STATE OF CONNECTICUT

PUBLIC UTILITIES REGULATORY AUTHORITY

RE: PURA INVESTIGATION : DOCKET NO. 12-01-10
INTO THE TREE :
TRIMMING PRACTICES OF :
CONNECTICUT’S UTILITY :
COMPANIES : DECEMBER 13, 2013

**WRITTEN EXCEPTIONS OF ERIC HAMMERLING
CHAIR, STATE VEGETATION MANAGEMENT TASK FORCE
EXECUTIVE DIRECTOR, CT FOREST & PARK ASSOCIATION**

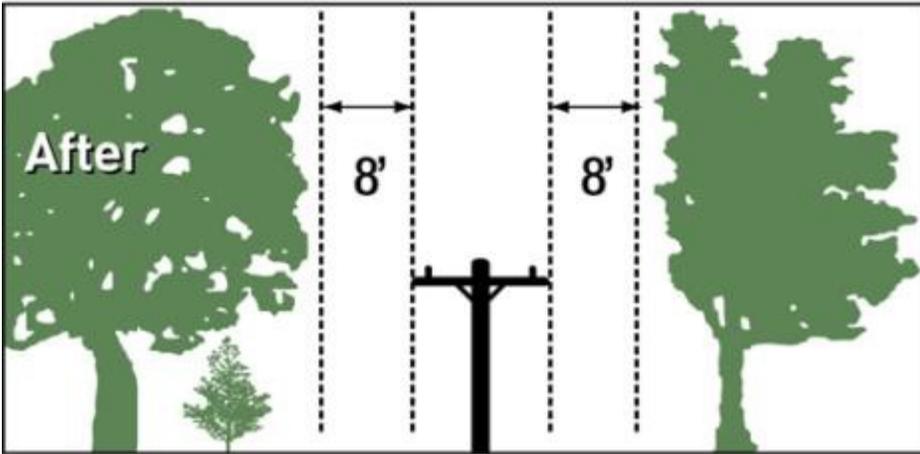
3. Under the heading, Vegetation Management Plan (section II. C 2a of the Draft Decision), the first two lines of the first paragraph should be changed to read as follows:

In accordance with the SVMTF recommendations, the EDCs shall file an annual vegetation management plan with the Authority that includes the following but not limited to:

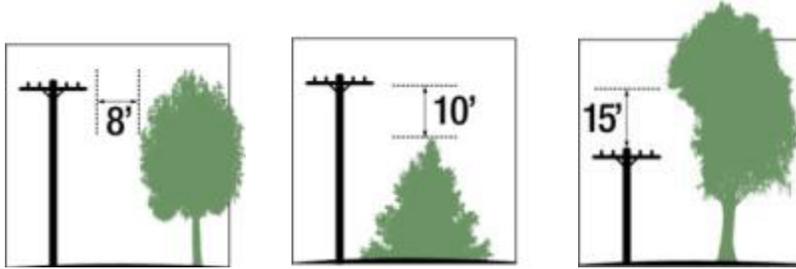
4. Under the heading, Line Clearance Requirements (section II. C 2. b of the Draft Decision), the text should be changed to read as follows (additions underlined; [deletions bracketed]):

1. Routine maintenance tree and brush work (tree pruning) shall be performed on a 4-year cycle. All roadside and off-road primary voltage lines shall be cleared at least once every 4 years.
2. The utility [clearance] protection zone shall be the area 8 feet to the side of all primary conductors from the ground to the sky.
 - a. Enhanced clearance shall be performed, subject to c below, to achieve the following clearances on all circuit backbone and lateral conductors selected for enhanced tree work: i) remove all tall growing tree species below within the clearance zone; and ii) remove all overhanging limbs within the clearance zone.

- b. Scheduled maintenance clearance be performed, subject to c below, to achieve the following clearance around all primary voltage conductors not selected for enhanced tree work: i) 10 feet below within the clearance zone, and ii) 15 feet overhead within the clearance zone.

c. In order to avoid negative aesthetic, societal, economic or environmental impacts, any non-hazardous tree located in whole or in part within the protection zone may be retained, provided that its species, condition and growth rate indicate that pruning without removal will reduce the risk of harm to the utility infrastructure.
